Product Change Notice (PCN)

PCN Number: PCN-0451140R-01

Product(s) Affected: PJ-035C

PREVIOUS CUI DEVICES DETAIL / IMAGE	NEW CUI DEVICES DETAIL / IMAGE

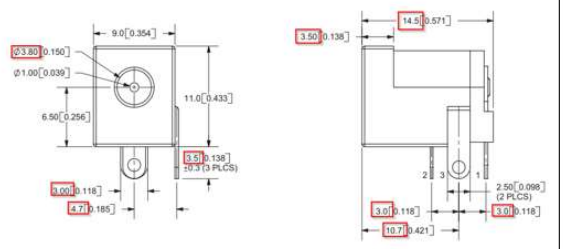
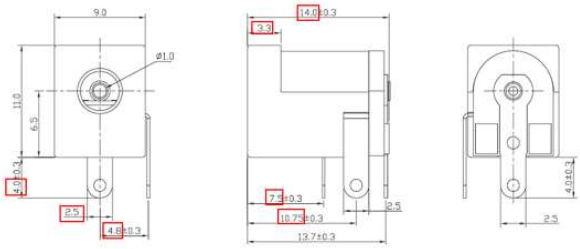
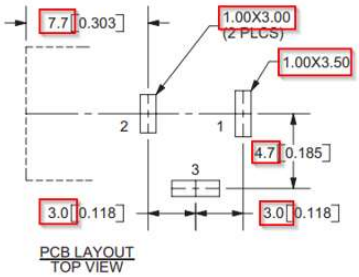
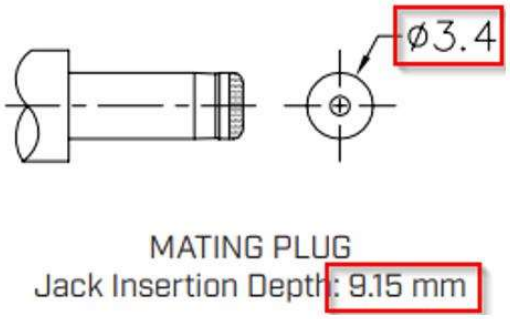
Description of Change: mechanical, and material differences as shown below:

MATERIAL	PLATING
center pin	copper	nickel
terminal 1	brass	tin
terminal 2	copper alloy	tin
terminal 3	brass	tin
plastic	PBT

DESCRIPTION	MATERIAL	PLATING/COLOR
center pin	brass	nickel
terminal 1	brass	tin
terminal 2	bronze	tin
terminal 3	brass	tin
cover	PBT (UL94V-0)	black
housing	PBT (UL94V-0)	black
